UNITED STATES PATENT AND TRADEMARK OFFICE

10/761,975

Office Action Summary

DETAILED ACTION

Fig. 5

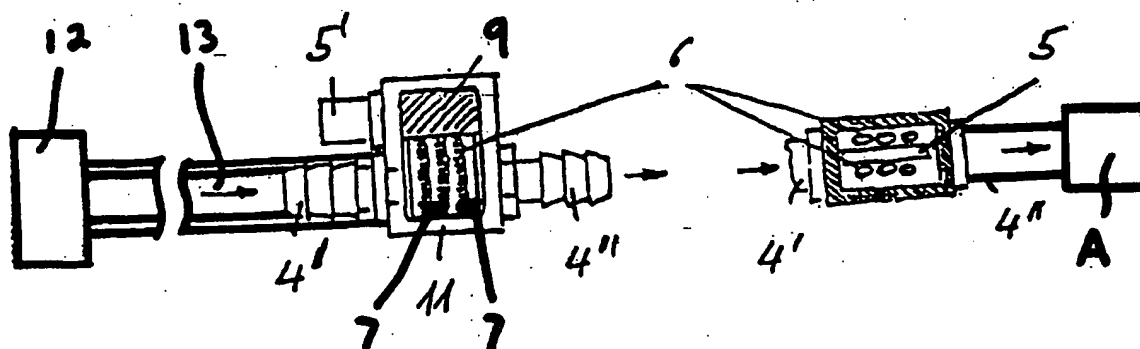
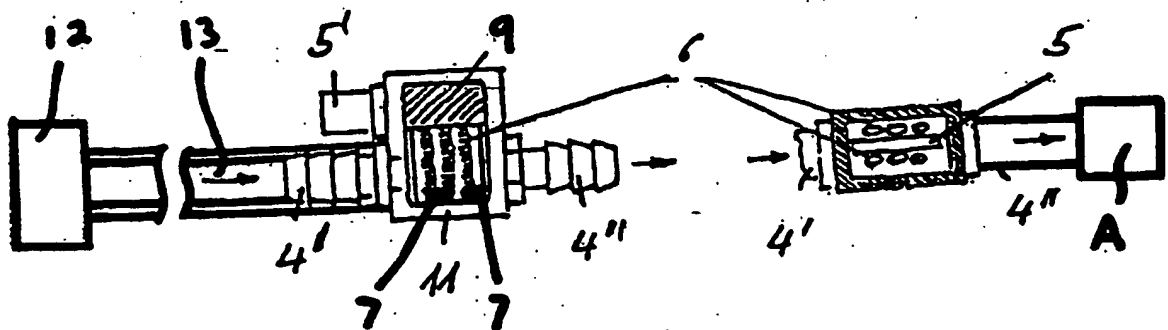
Applicant is reminded of the election of species D figure 5 in paper filed 11/23/05. The claims are no longer generic as previously argued.
